DEPARTMENT OF PLANNING AND COMMUNITY DEVELOPMENT

CASE NOS.: 06-CUP-005 and 06-OTP-008 (Amendment)

LOCATION: 6160 Fairview Place
(A.P.N. 2055-023-109)

REQUEST: Request for approval of a Conditional Use Permit and Oak Tree Permit Amendment for changes to the approved grading plan and associated changes to the landscape plan.

Photo 6A – Restored Open Space

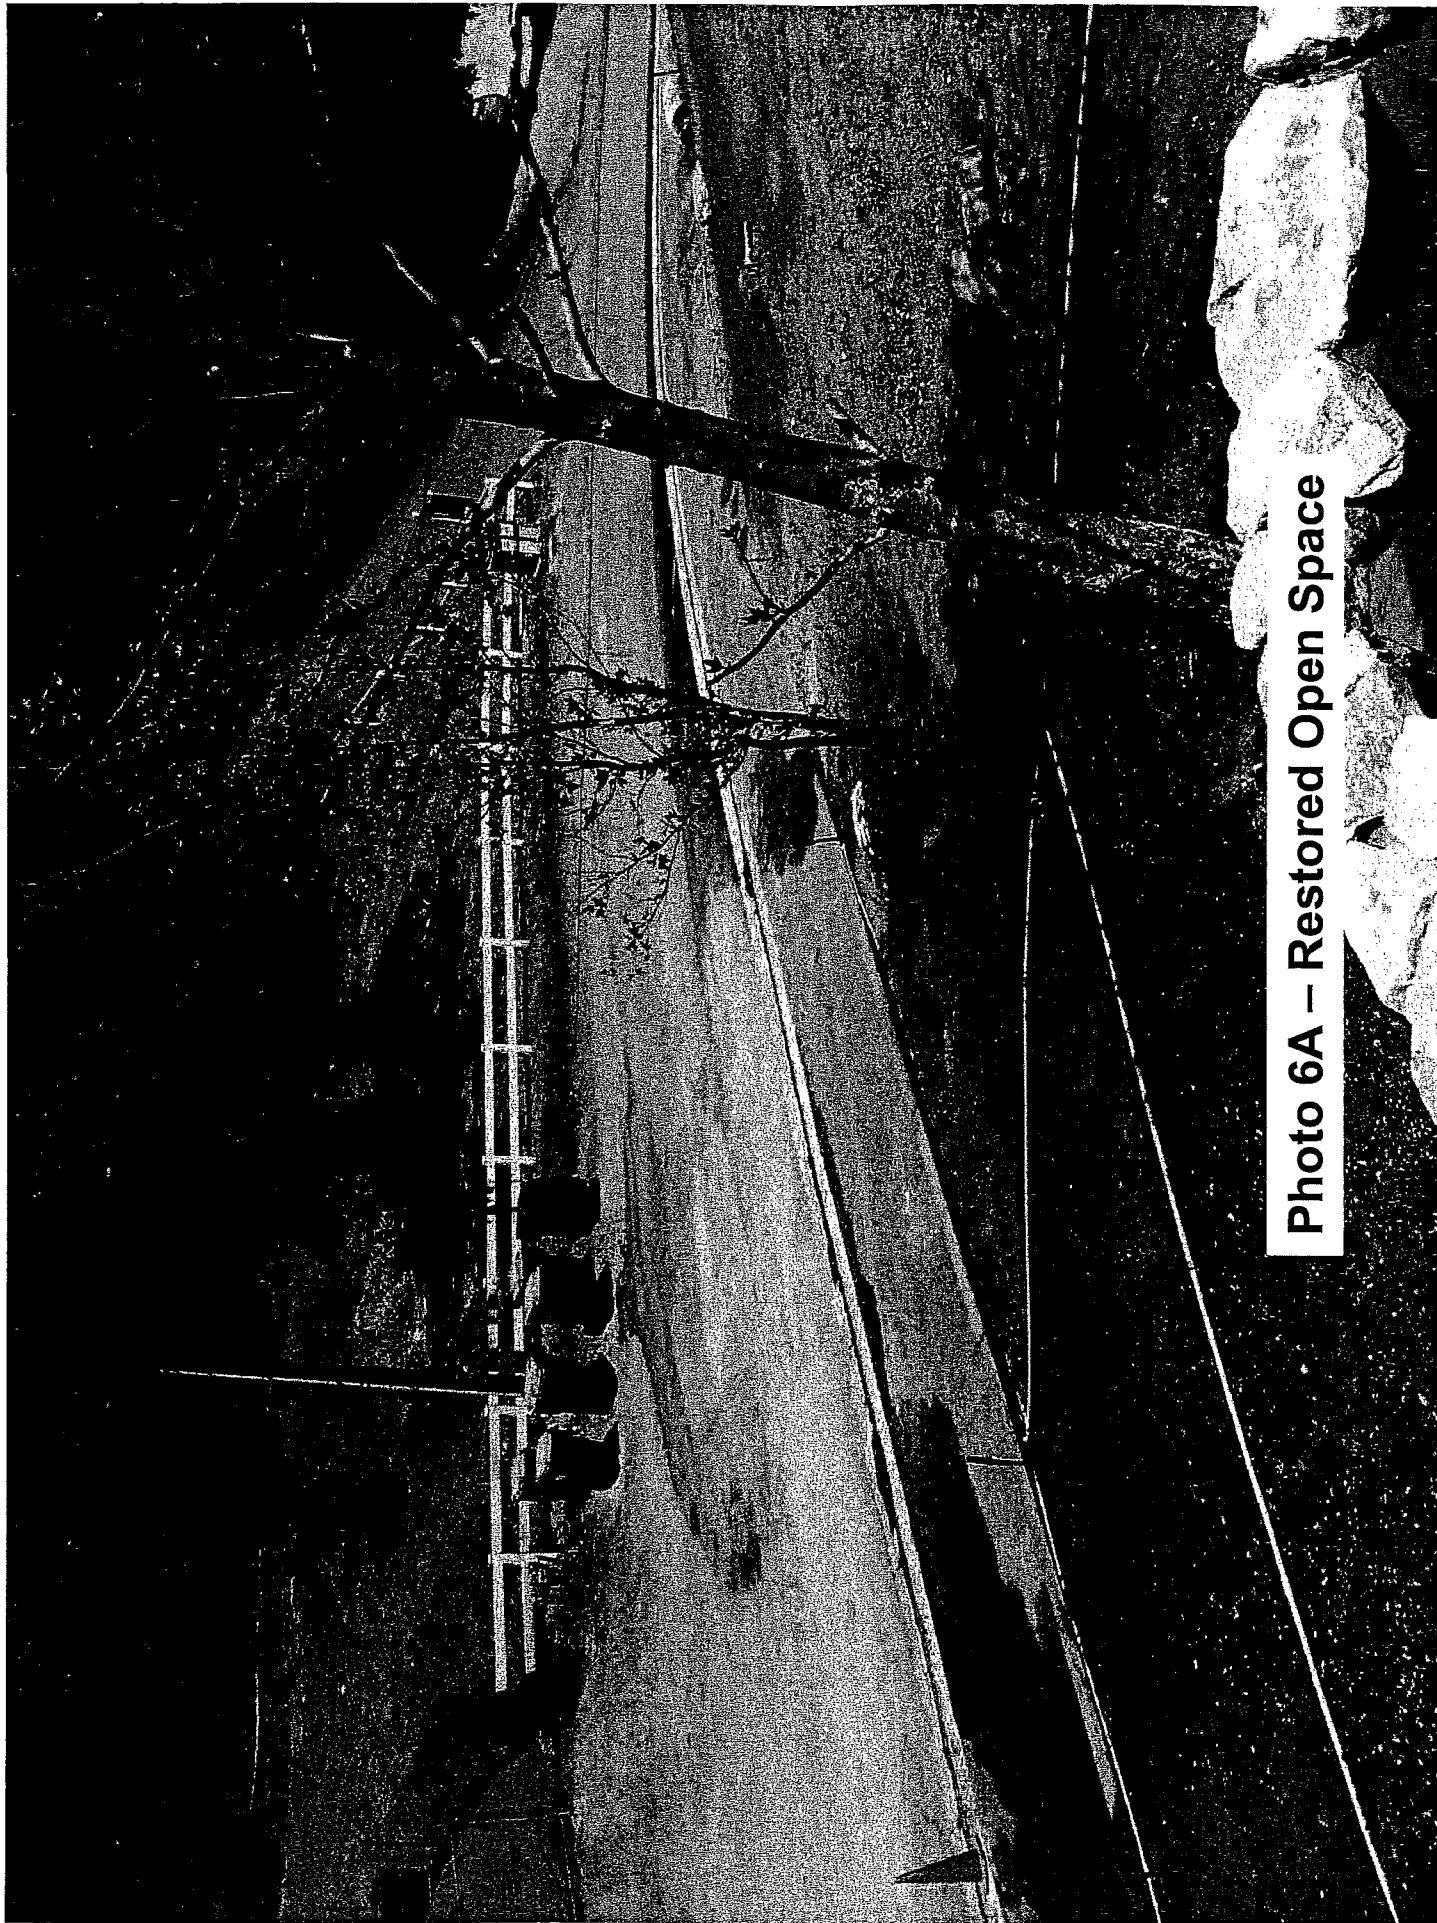
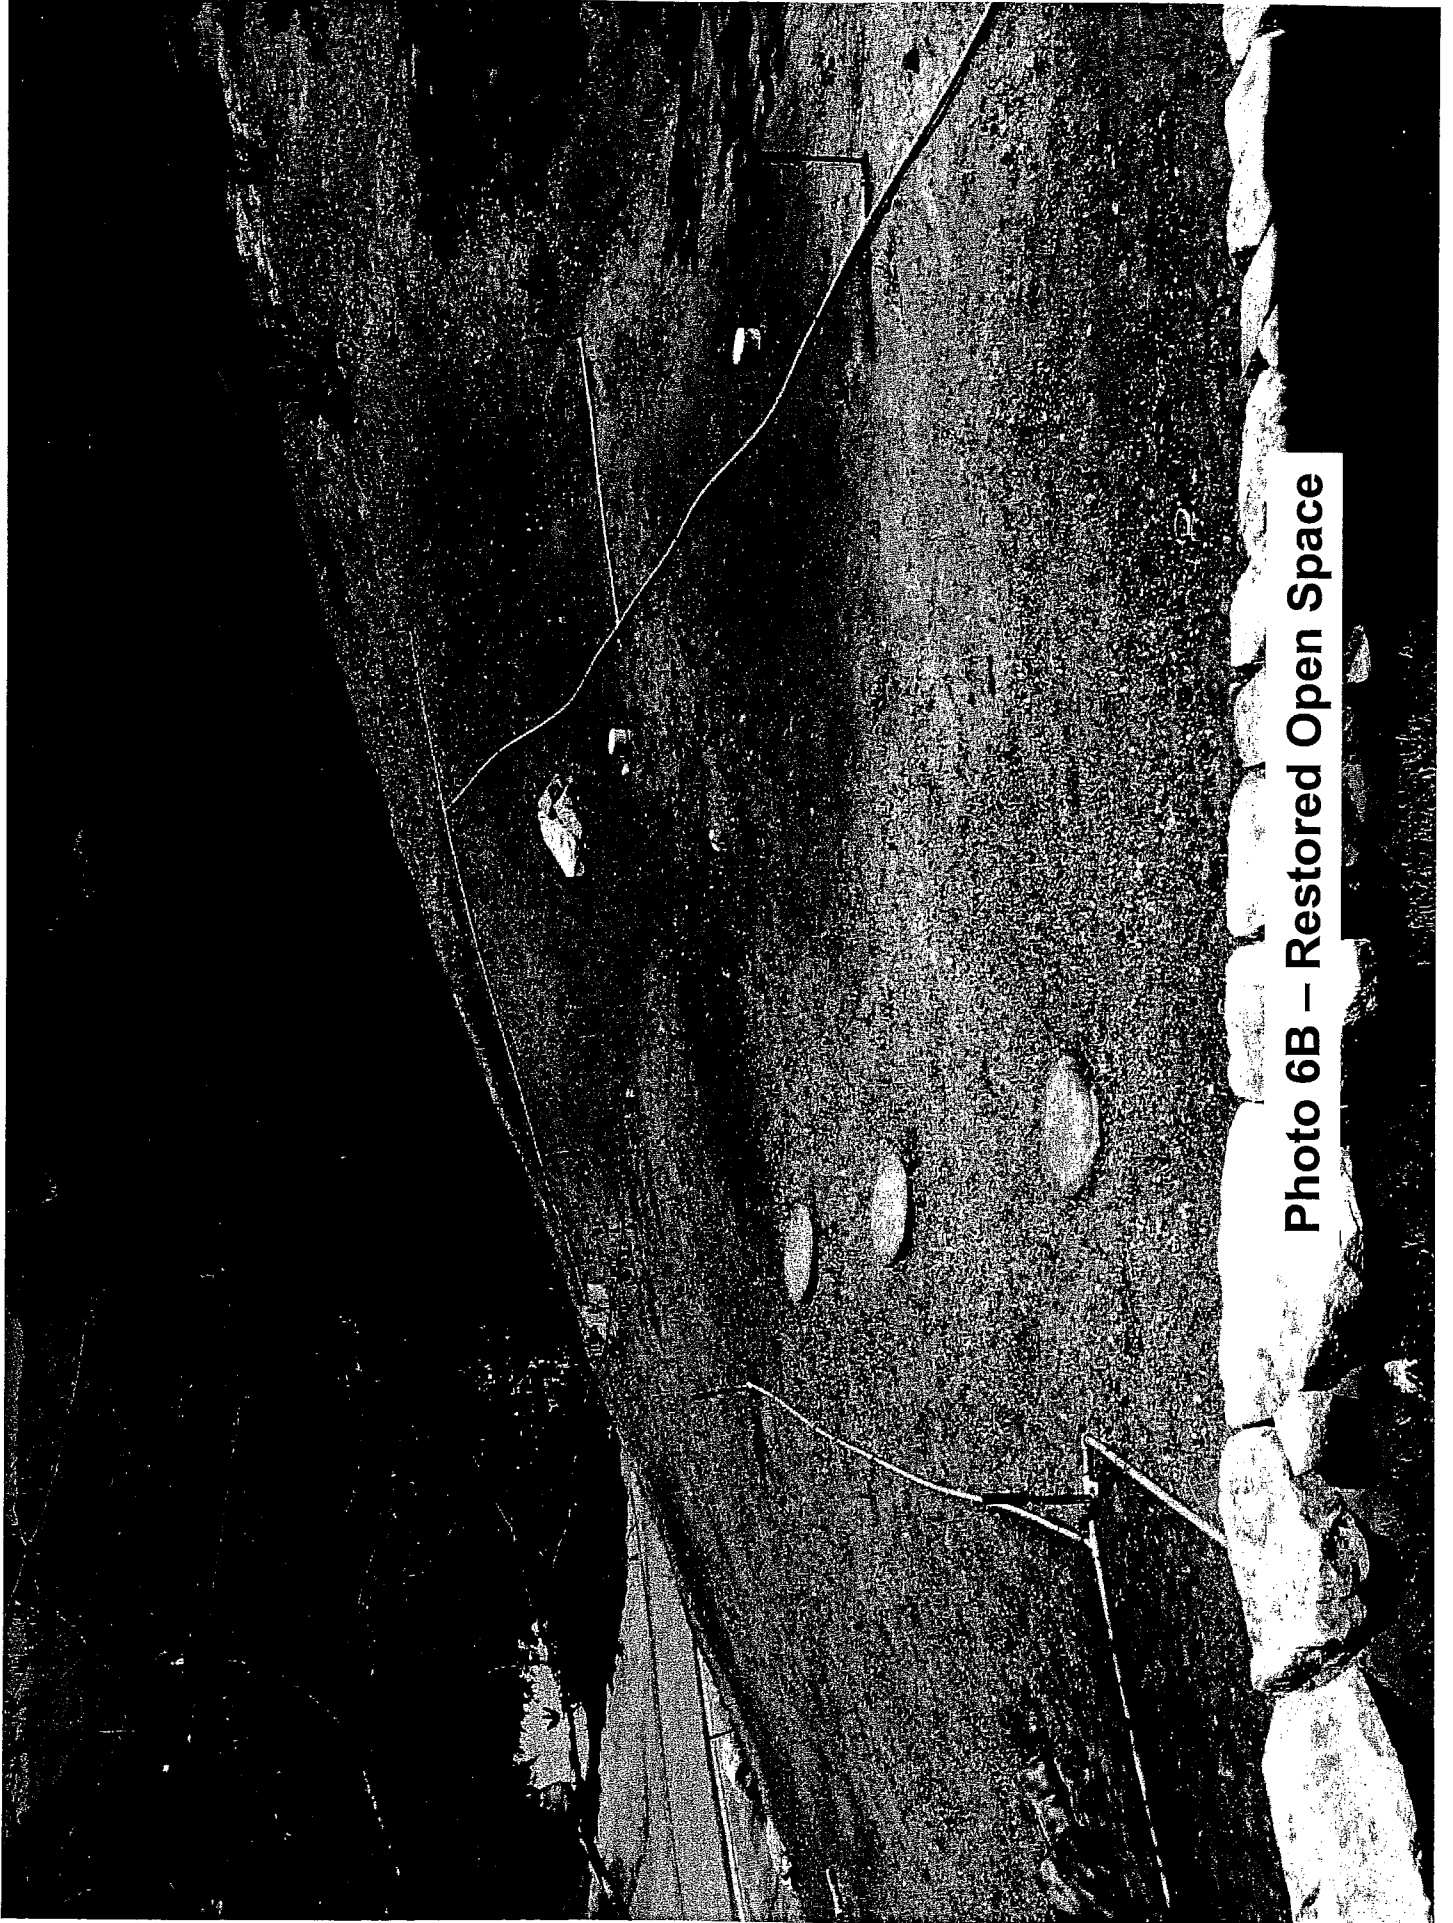
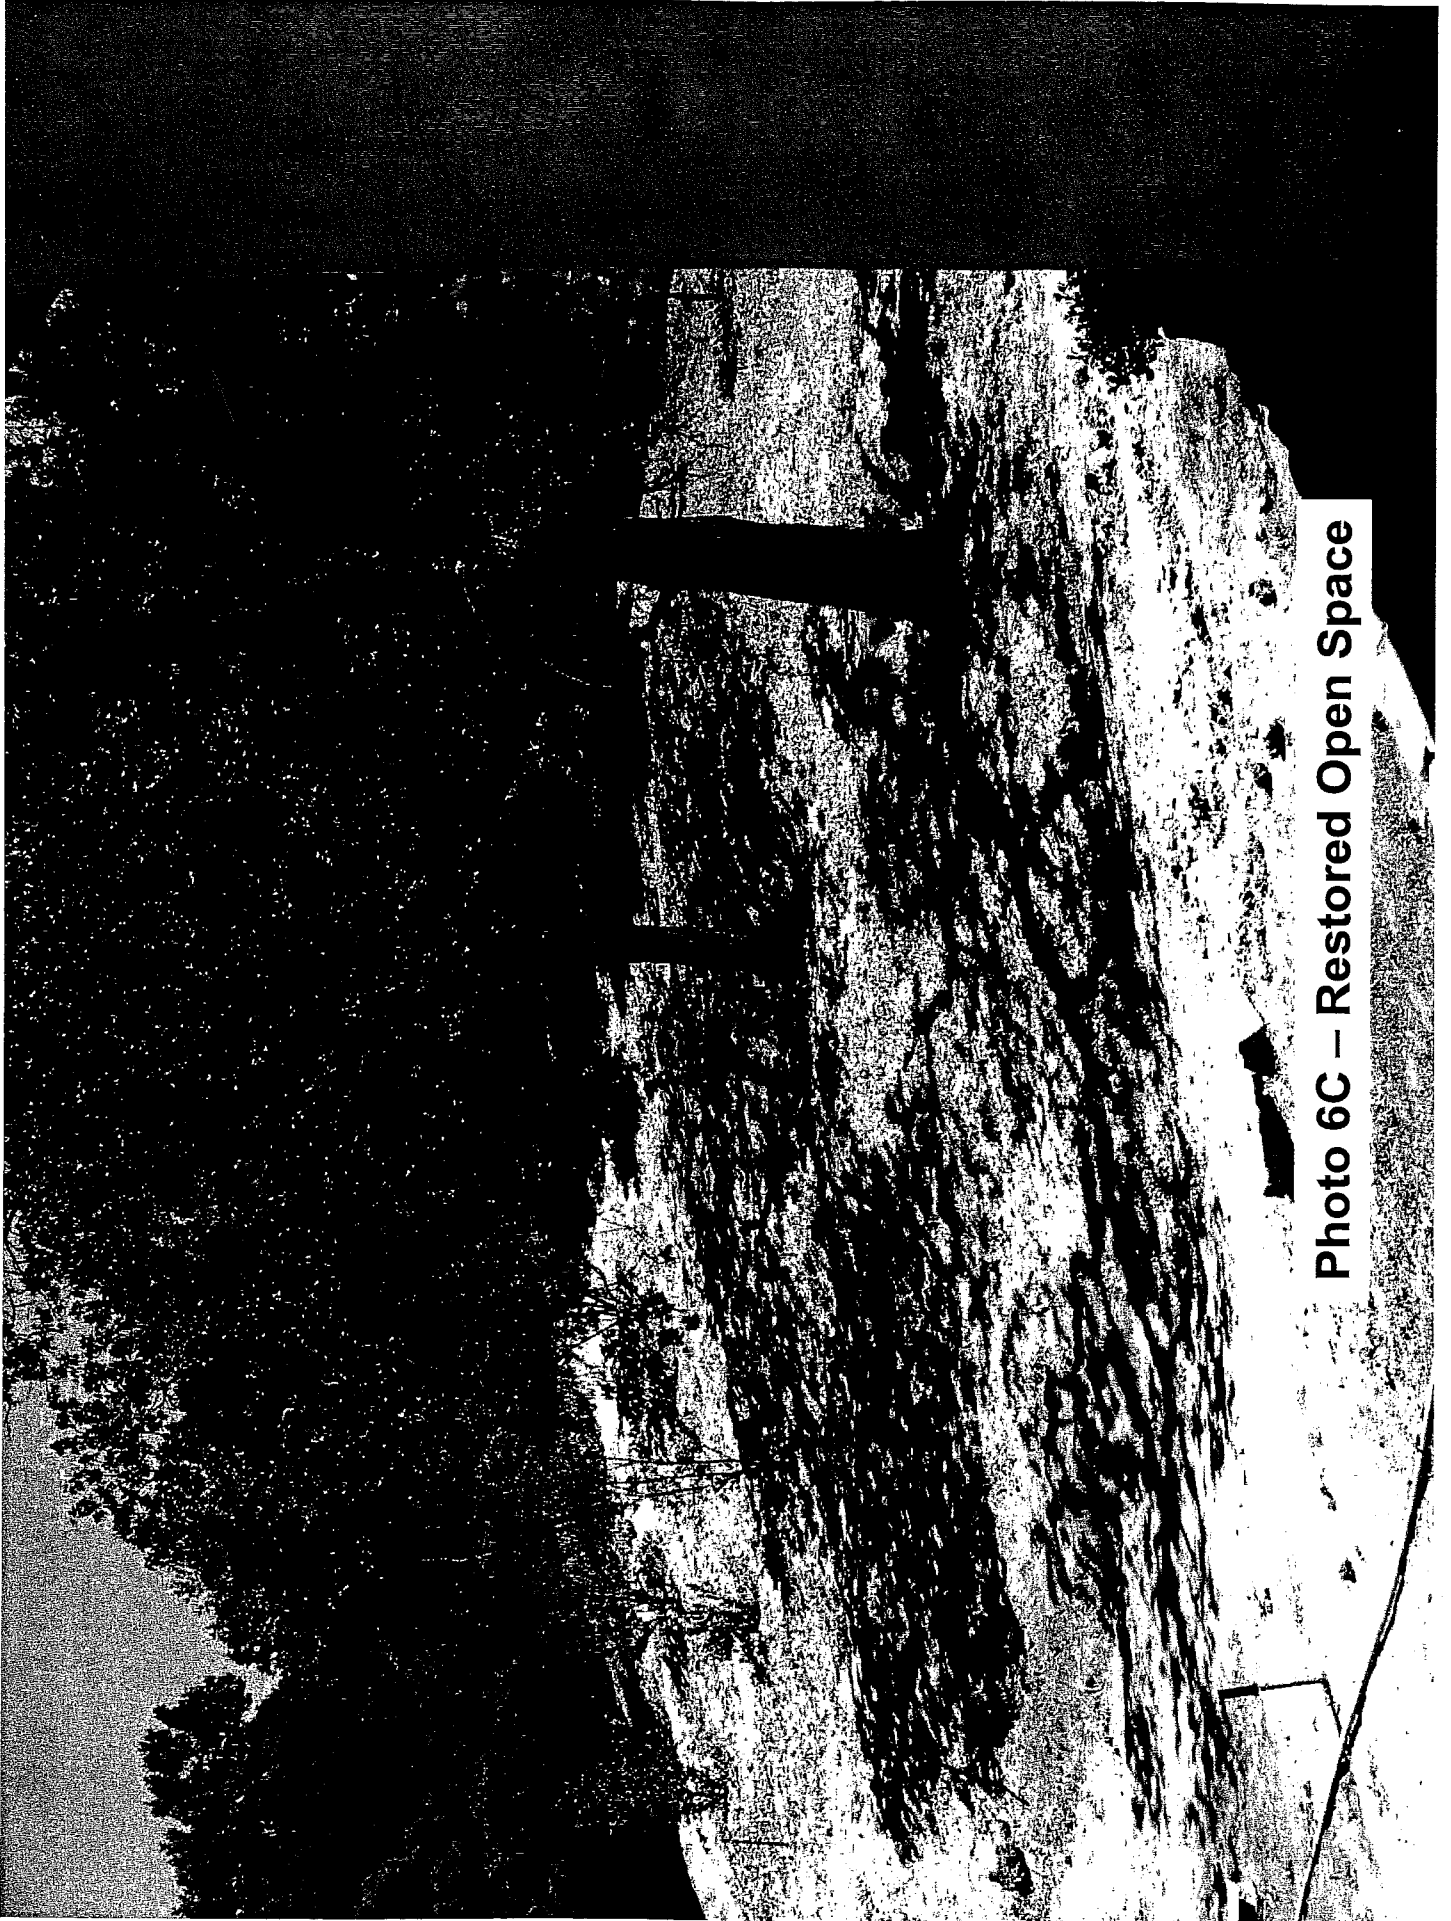
Pursuant to the approved landscape plans for the original project, and under the direction of the City’s landscape and oak tree consultant, Kay Greeley, in the “restored” area, Mr. Gray has

planted coyote brush, a native plant, and installed temporary irrigation, with the goal of making this area similar in appearance to the undisturbed portion of the site. (See Photos 6A, 6B, 6C.)
